9/18/2024 | 6:00 PM

**Municipal Services Center, Council Chamber
3600 Tremont Road**

- a. Approve the August 21, 2024 and September 4, 2024 meeting minutes.
- b. 2745 Camden Road (VAR-55-24) - To allow an expanded patio that results in 35.2 percent front yard development coverage along Northam Road when 25 percent is the limit.

- a. 2459 Tremont Road (VAR-50-24) - To allow two HVAC units that are one-foot from the side property line, when a three-foot minimum is required.
- b. 1662 Doone Road (VAR-51-24) - To allow a detached garage that is 19 feet in height, when 17 feet is the limit and has a top wall plate height of 10 feet, when 9'-6" is the limit.

Proposed Site Plan

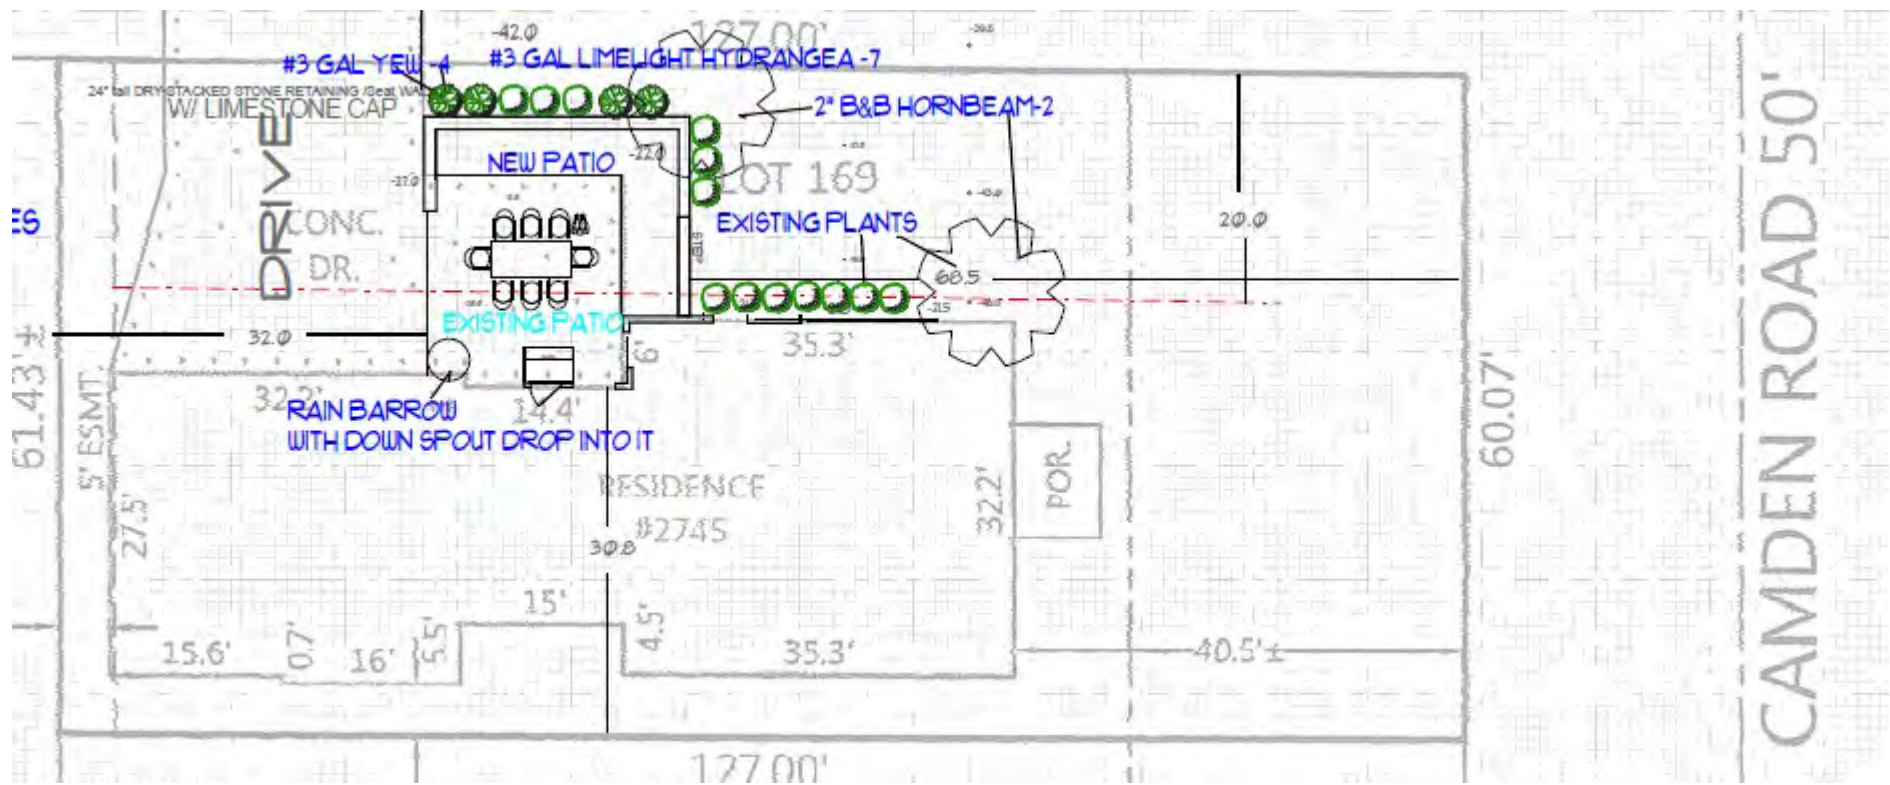
The application includes the installation of an expanded patio and seatwall within the Northam Road front yard. The 350-square foot paver patio expansion will be bordered by a 30-inch tall stone seat wall, with Yew and Hydrangea bushes to help screen and soften the hardscape. The mature tree near the patio that was recently removed will be replaced with a Hornbeam. All other existing plants are to remain. Overall building and development coverage are compliant with City standards, but the proposed plan would exceed the front yard limit by 261 square feet. The patio will be sloped to drain toward the street and a rain barrel is proposed near the house to help with stormwater.

Staff has reviewed the application and plans, discussed it with the applicant, and visited the site. As the Board is well aware, homes on corner lots are "penalized" by having two front yards, which pushes development to the rear corner of the property, thus limiting development potential in order to preserve front yard greenscapes and open vistas. At the subject property and due to the placement of the existing home and wide driveway, there really is no space to add a patio in the side and/or rear yards, hence the existing patio in the front yard. The applicant has discovered this space is not large enough to accommodate their family and want to take advantage of viewing park activities.

The Board is also well aware of development coverage requests and their difficulty with support primarily due to aesthetics and stormwater, and has historically held requests in the front yard to around 30 percent with a number of conditions. In this case, a wide driveway already exists and will not change as access to the property would be significantly impacted (Finding #6). The patio would face a narrow, busy road and will not be visible from the street due to a quality landscape plan. Based on the applicant's revisions, the plan is not excessive (Finding #3). For these reasons, Staff recommends that this application be approved.

SITE PLAN
SCALE: NOT TO SCALE

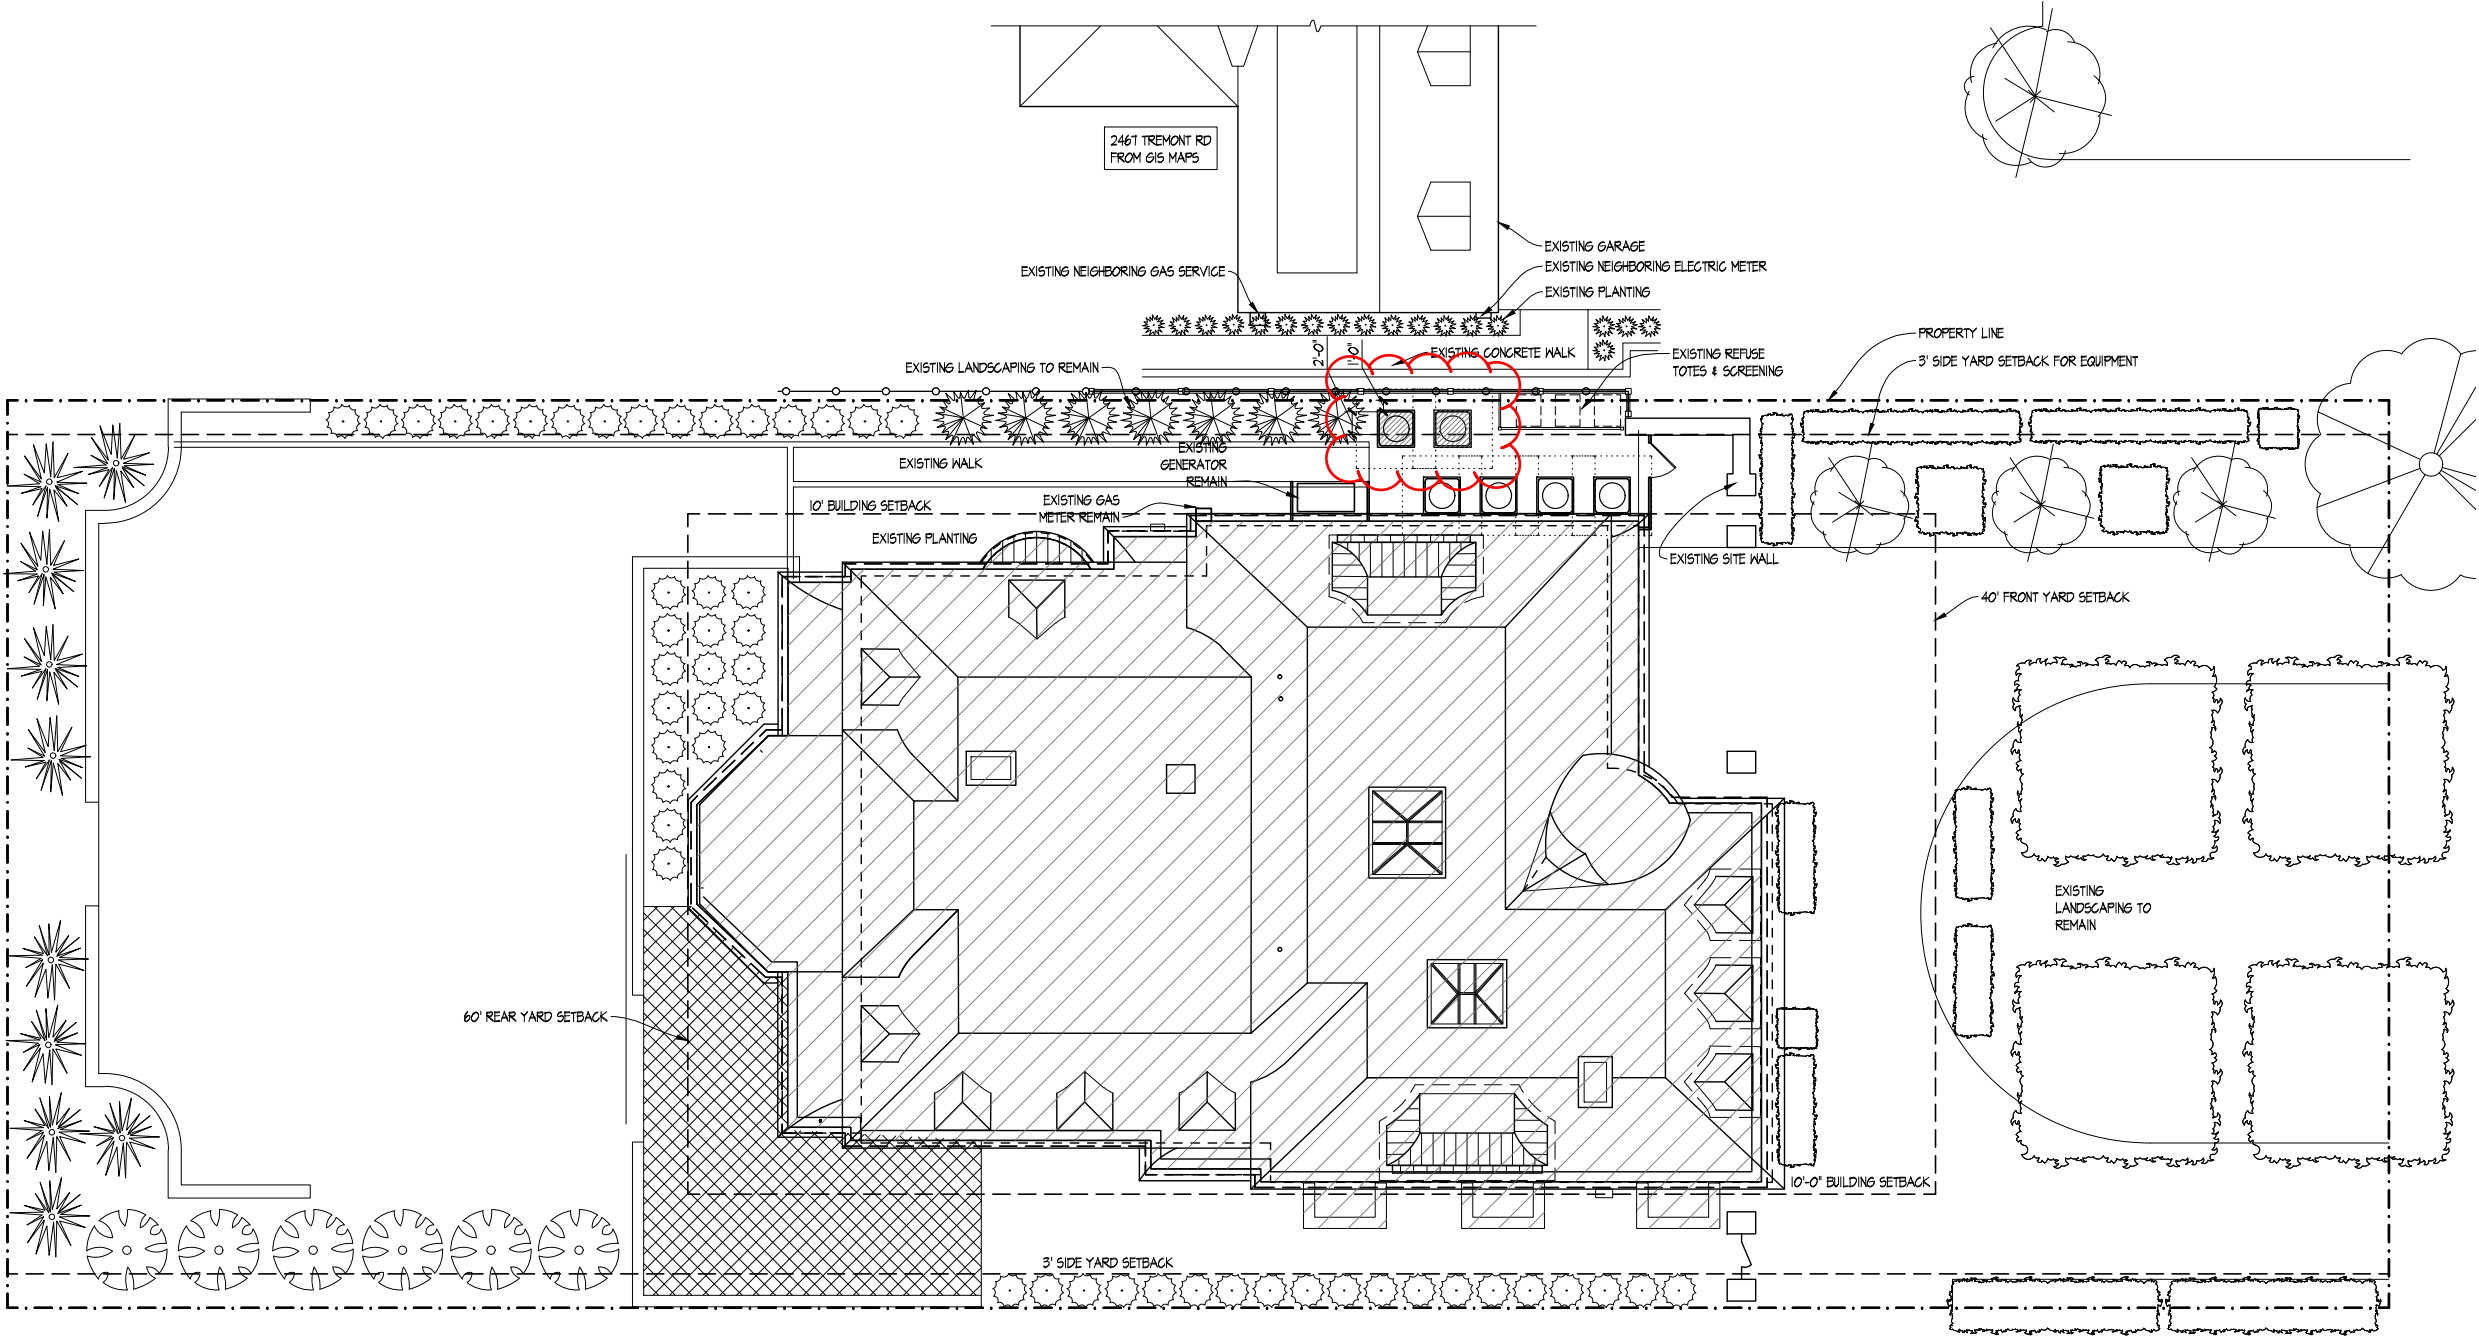
The proposal includes the installation of two HVAC units along the north side yard of the property, just one-foot from the property line. The units would be identical to the existing four units along the house and would provide optimal conditioning of the home. Each unit is 3' x 3' x 3.5' and would have an output of 56 decibels (below the 60 decibel limit). A walkway of just under three feet in width would run between the HVAC units and an existing six-foot tall wood privacy fence and brick wall screen the units from view. The applicant has indicated that existing mature landscaping and the larger (but quieter) size of the units make it difficult to locate along the side property line.

Staff has reviewed the application and plans, visited the site, and discussed with the applicant. The proposed location of the HVAC units along the north side yard of the property positions them in a nearby location where units already exist and behind a privacy fence along the side property line and a brick wall that screens the units from the front yard. Additionally, the applicant has indicated that the adjacent neighbor is supportive of the location; it is adjacent to the neighbor's garage. At the same time, Staff is not aware of similar requests that have been approved by the Board and is concerned with the precedence an approval could set. The purpose of the three-foot setback is to buffer potential impacts of noise and aesthetics and create ample space for maintenance of the units.

PROPOSED SITE PLAN

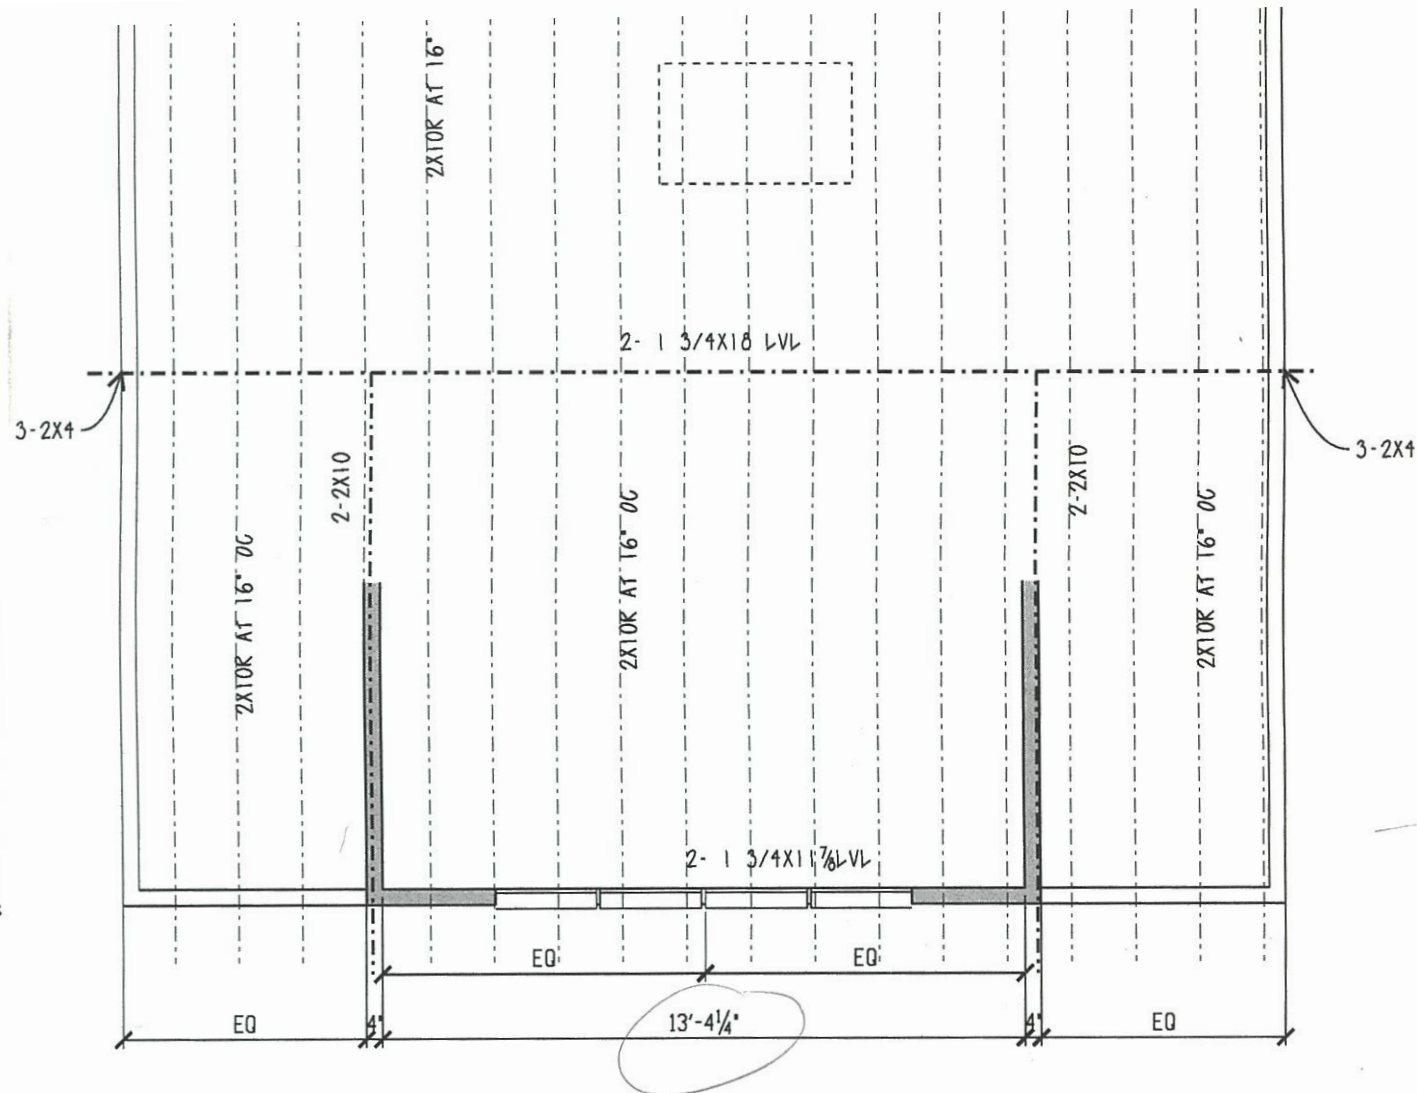
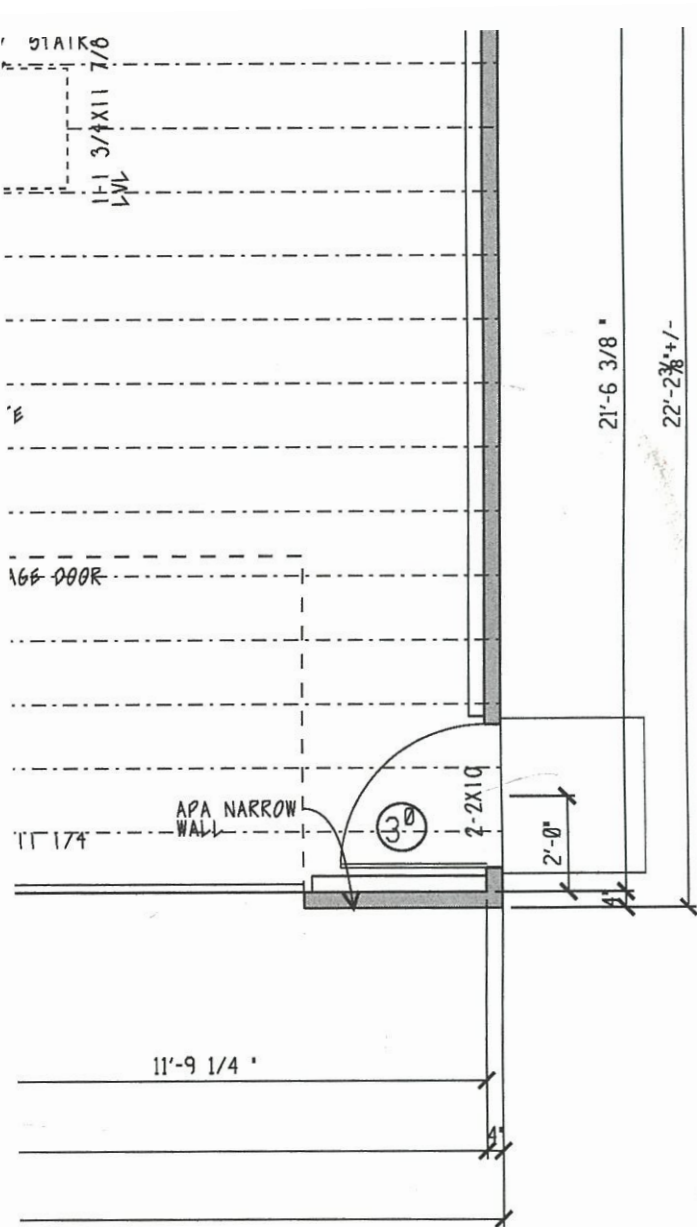
The application includes the demolition of the existing 550-square foot detached garage and the construction of a 537-square foot one in its place, on the same foundation. A Building Permit was issued for this detached garage in 2018, but never built, and now the applicant wishes to make changes. The revised plan increases the height by two feet, to just under 19 feet, and increases the plate height by six inches, to 10 feet. This would allow for a taller unfinished second floor storage area, accessed via drop-down staircase. The exterior includes hardi-plank siding, with a dormer window facing the street and a dormer on the rear elevation. Resulting building, development and front yard development coverage are largely the same and below City standards.

Staff has reviewed the application and plans, discussed it with the applicant, and visited the site. The application proposes the replacement of an existing detached garage that is largely in the same location and size, just taller. The Board has granted several recent detached garage height variances to allow for a home office or similar space. The application here is quite different, though, in that three variances are needed, and unfinished storage is proposed on the second level. The plan for a detached garage with second-floor storage space would be similar to hundreds of detached garages approved by the City prior to allowing habitable space on the second floor. Staff has reviewed nearly identical plans during Building Permit review, where the heights can be reduced and rear dormer removed to avoid requesting variances (Findings #7 and #9). Allowing extra height for unfinished second floor storage would be a departure from recent cases and could be precedent-setting. Staff is also concerned about the rear-facing dormer as it would loom over two neighboring rear yards, as well as the exterior of the detached garage not matching the house. For these reasons, Staff cannot support the application at this time.

SITE PLAN - NEW WORK

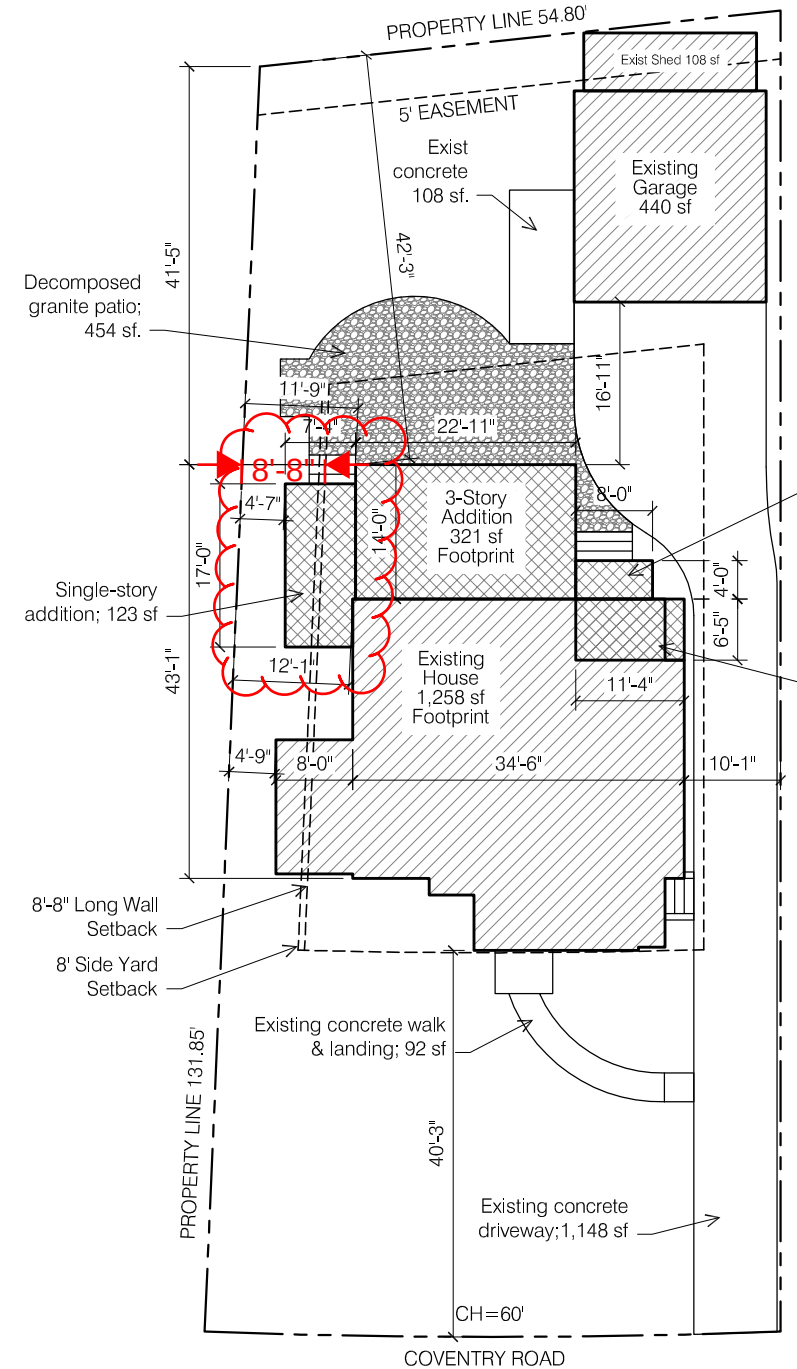
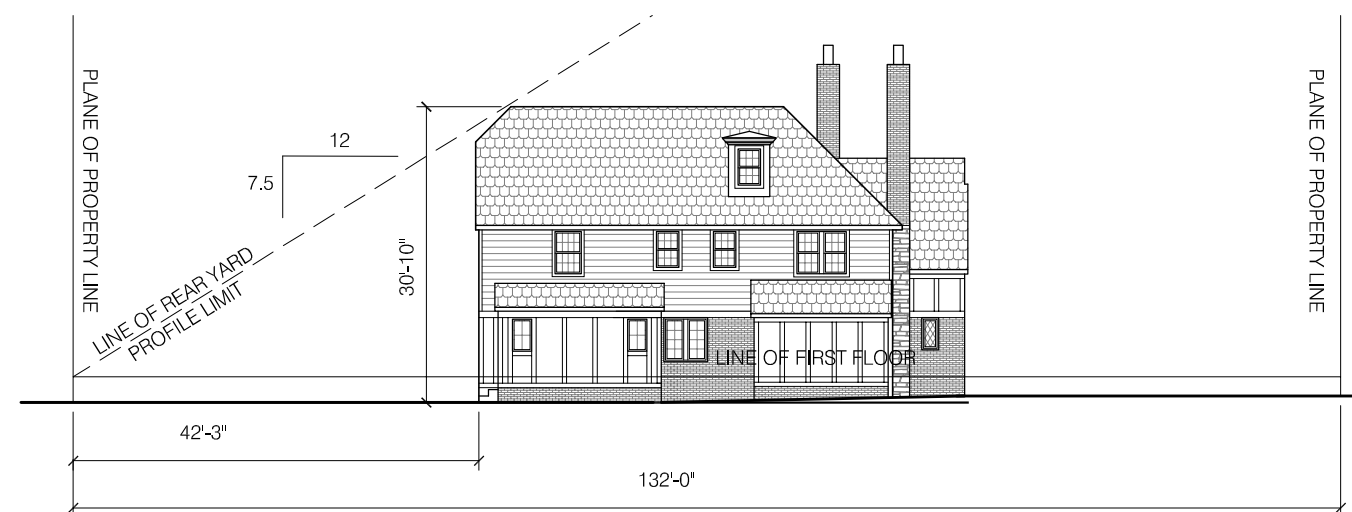
REQUEST VARIANCE
 1. To reduce the south side yard setback from 8'-0" to 4'-7".
 2. Reduce the south long wall setback from 8'-8" to 4'-7".
 2. Increase building coverage from 29% to 30%.
 3. Increase allowable third floor area from 486 sf (33%) to 634 sf (43%).
